SBK-L-11245

Seabrook Station

License Amendment Request 11-04

Changes to the Technical Specifications for New and Spent Fuel Storage

Figure 3.9-1
Fuel Assembly Burnup vs. Initial Enrichment
For Spent Fuel Assembly Storage

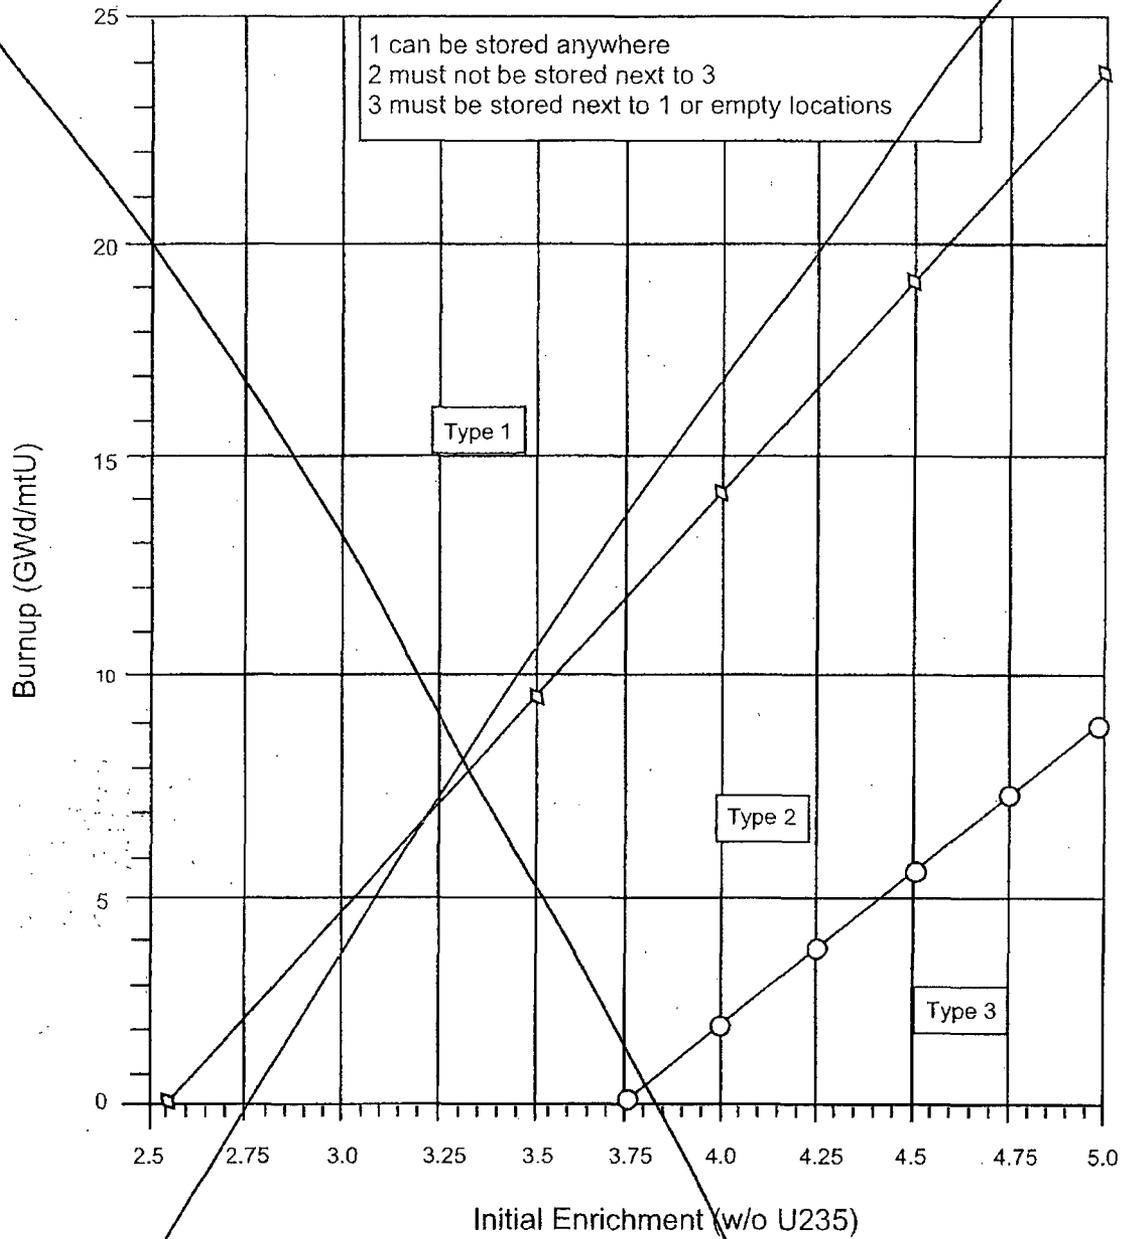
Figure 3.9-1

Figure 3.9-1 is deleted and replaced as follows; (1) the burnup and enrichment requirements are moved to Section 5.6.1 and (2) the burnup and enrichment requirements are converted to tabular form (Table 5.6-1).

DELETE

Justification: This change is editorial. All fuel storage requirement data is being relocated to the Design Features (TS 5.6)

Figure 5.6-2

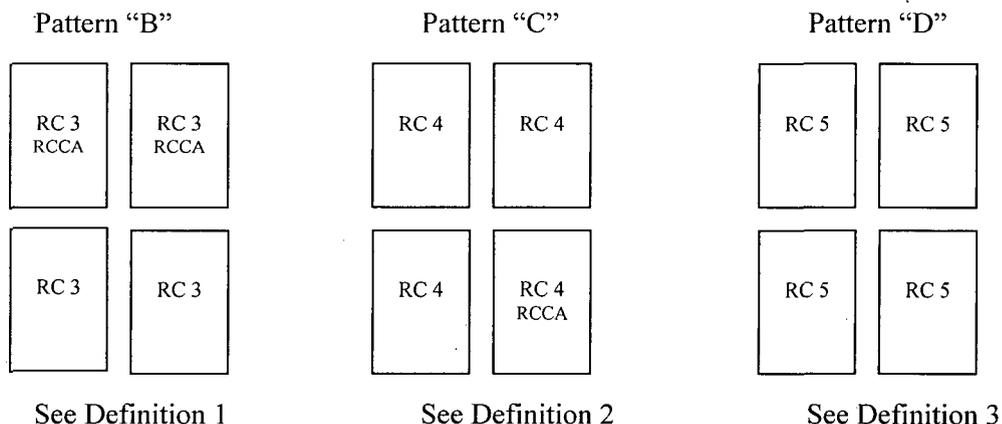
Figure 5.6-2

Figure 5.6-2 is added to provide the Region 2 storage arrays allowable for placement of fuel.

Justification: The revised spent fuel storage patterns align with the criticality analyses described in this evaluation and in Attachment 2.

- b. Any 2x2 array of Region 2 storage cells containing fuel shall comply with the storage requirements defined in Figure 5.6-2 and the requirements of Table 5.6-1 or with the allowable exception of evaluated assemblies stored on the periphery of Region 2 as defined in 5.6.1.3.c. The evaluated assemblies are listed in Table 5.6-2.
